November 12, 2024

Addendum #2
 Jungle of the Apes Workspace Remodel RFP 2024
 Project Number: 2024-01-042

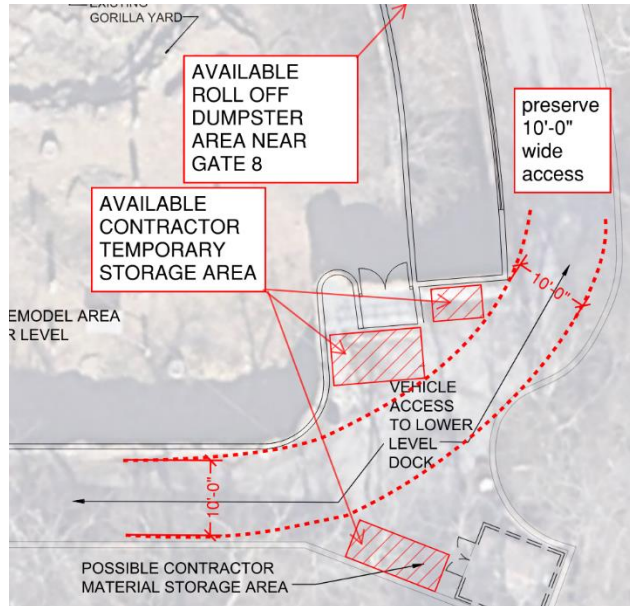
1. In the alternate 2 area, by what entrance would dirt be moved to and stored? **The section of the public path below will be closed during excavation and waterproofing and available for excavated soil and equipment to be stored on plywood. See pictures below.**

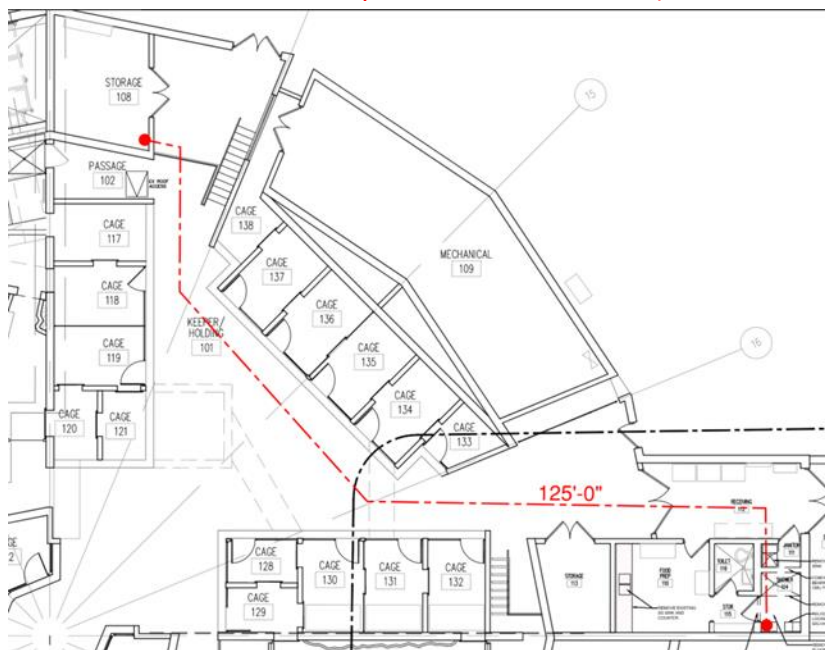
- Where can a roll off dumpster be stored? Temporary storage is available as noted along the service drive. A more permanent location, if needed, will be inside service Gate 8 near the site. See picture below.

Clip above from As-Built Plan: showing approximate location of 3 steel poles in landscaped area.

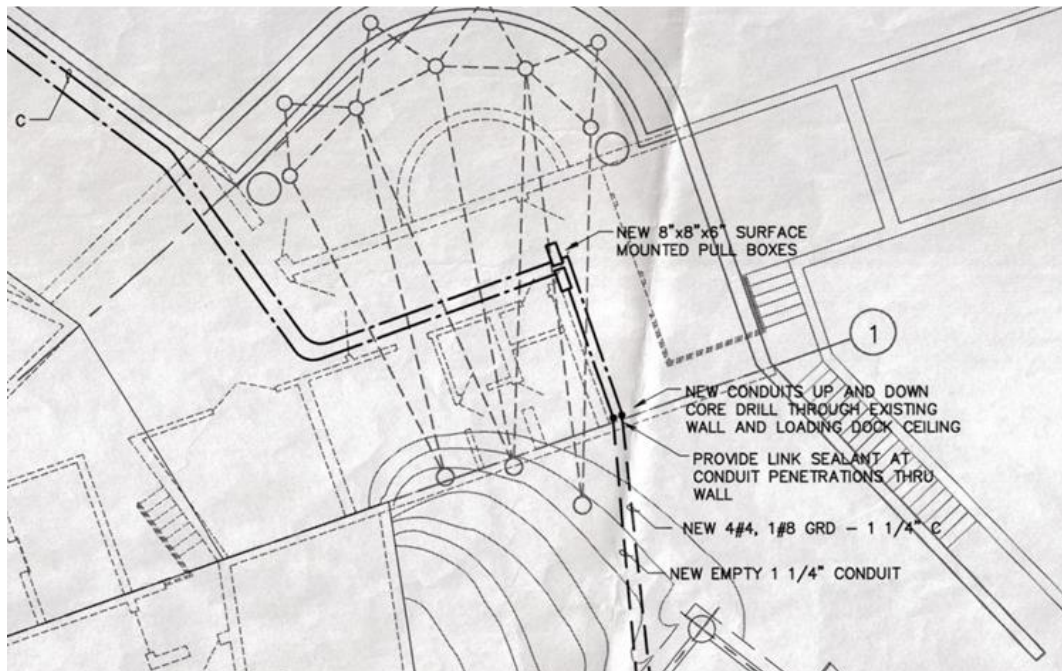
ALTERNATE #2 SUPPLEMENTAL NOTE

There are 3 steel horticulture posts wrapped with bamboo in the landscaping which may be within the excavation zone. If so, these can be removed and do not need to be replaced.
